Detour Concurrence Only

PENN D.O.T.
APPROVED *AS NOTED*
[Signature]
TRAFFIC UNIT 6-0 3/12/19
(Additional signs marked in blue)

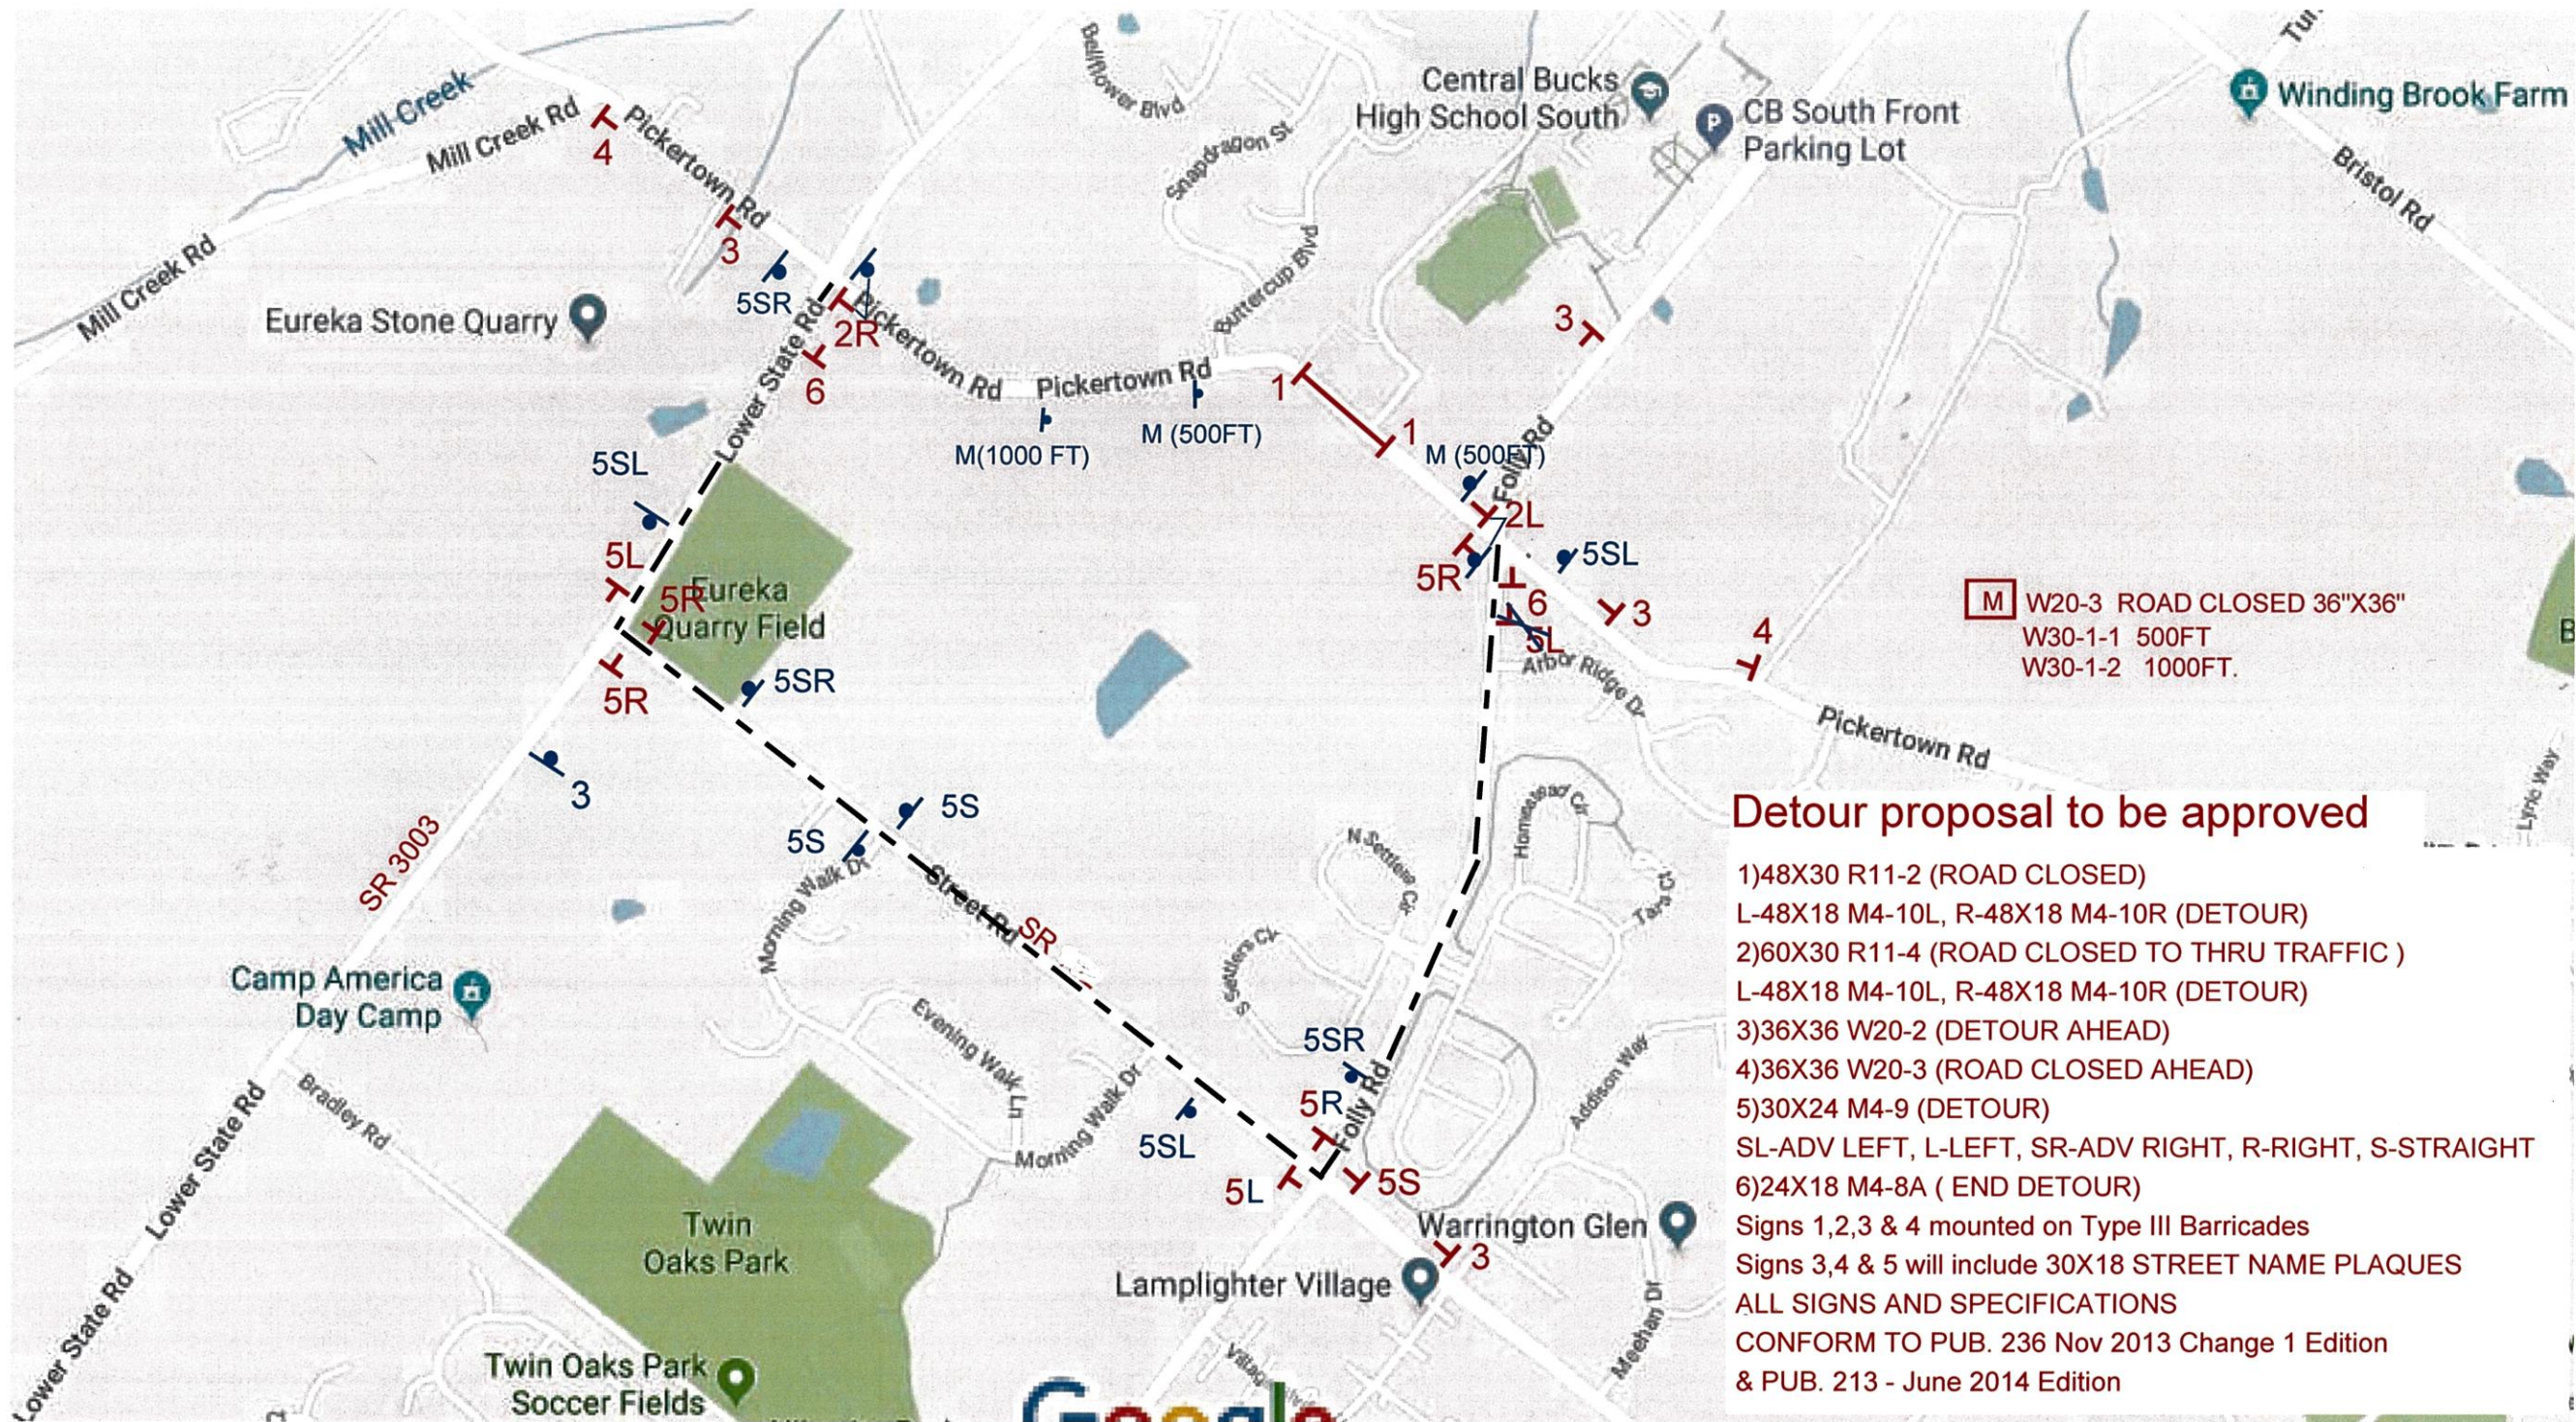
CHECK WITH TOWNSHIP AS THERE ARE SIGNS NO LEFT TURN FROM PICKERTOWN RD TO FOLLY RD FOR TRUCK MORE THAN 25' LONG..AND SIGNS AT JUNCTIONS OF FOLLY RD AND STREET ROAD , NO TRUCK ALLOW MORE THAN 10000 LB .
